ASC Competition Commercial, Region 7

REQUEST FOR INFORMATION

PHX Sky Train - Stage 2

DRILLED SHAFTS VERTICAL REINFORCEMENT AND MIX DESIGN CONFIRMATION

B02-GWSG0801

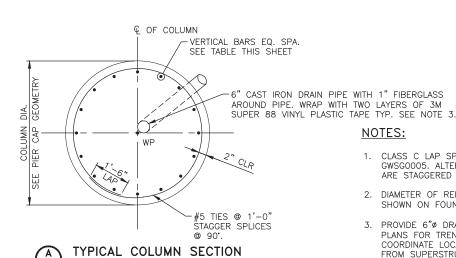
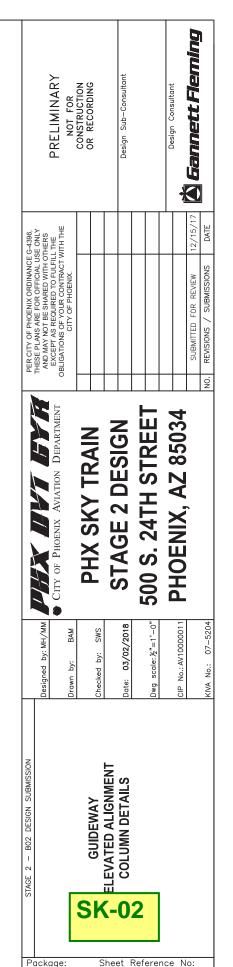
In addition, detail 2 on GWSG0801 notes the dowels from the drilled shaft to column are to have "Class C" lap splice. Per Bar Splice table on B02-GWSG0003, the lap splice required is 101", however 141" splice has been provided (see SK-01 thru 02).

2. Please confirm it is structurally acceptable for the vertical shaft dowels to have a 141" lap splice with column reinforcement.
